One Earth Solar Farm

Applicant Response to Deadline 2 Submissions

Document Ref: EN010159/APP/9.23

September 2025

Drawing Title:
Baseline Watercourse Conditions

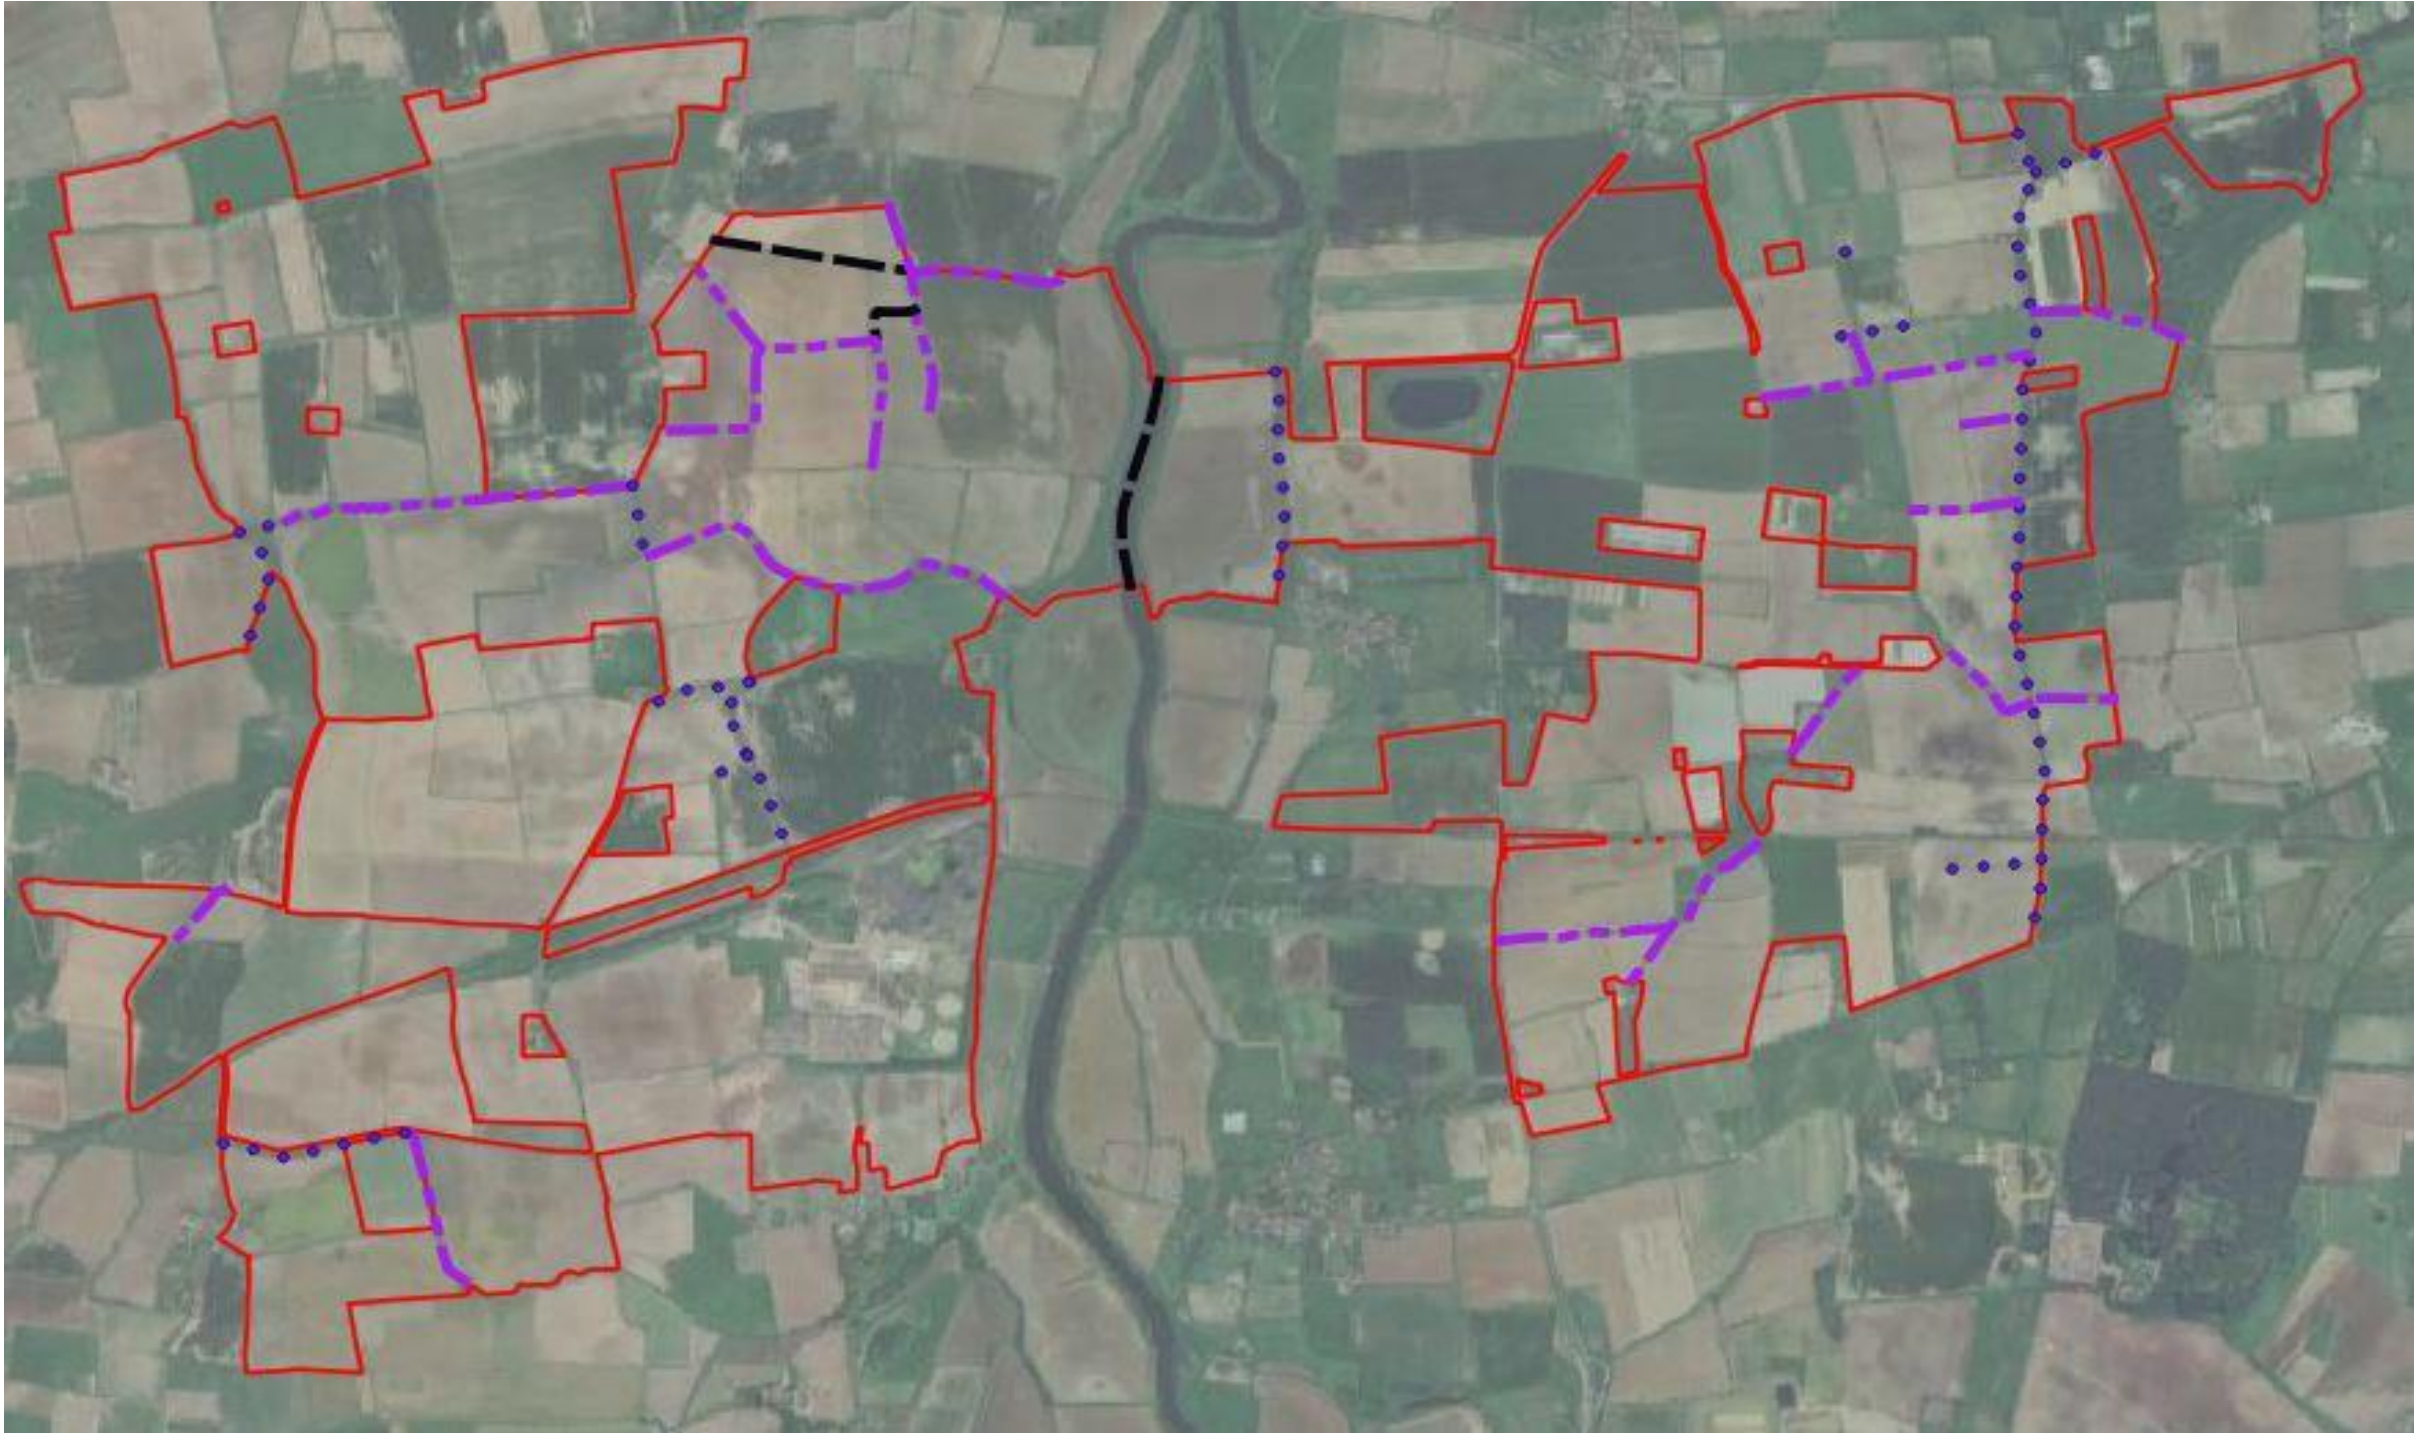
| App Ref | Ref | Respondent | Question Summary | Applicant Response |
|---------|--|--------------------|---|---|
| D2R11 | Biodiversity [REP2-094] | Environment Agency | <p>Issue: <i>'As part of this a separate watercourse map will be provided within the Appendix 6.10 Biodiversity Net Gain Assessment [APP-093] showing the location of all ditches and watercourses with appropriate colours to differentiate those in different habitat condition'. It would appear this map has yet to be produced</i></p> <p>Impact: Habitat classifications used to inform BNG assessment have not been verified.</p> <p>Solution: We would welcome opportunity to review the map alongside other information used to support habitat classification (distinctiveness and condition).</p> <p>Information presented within updated Appendix 6-3 paragraph 3.12.8 is noted, further supporting information is requested to support this assertion (that this watercourse is not 'other river or stream').</p> | A figure has been appended at Appendix A as requested. |
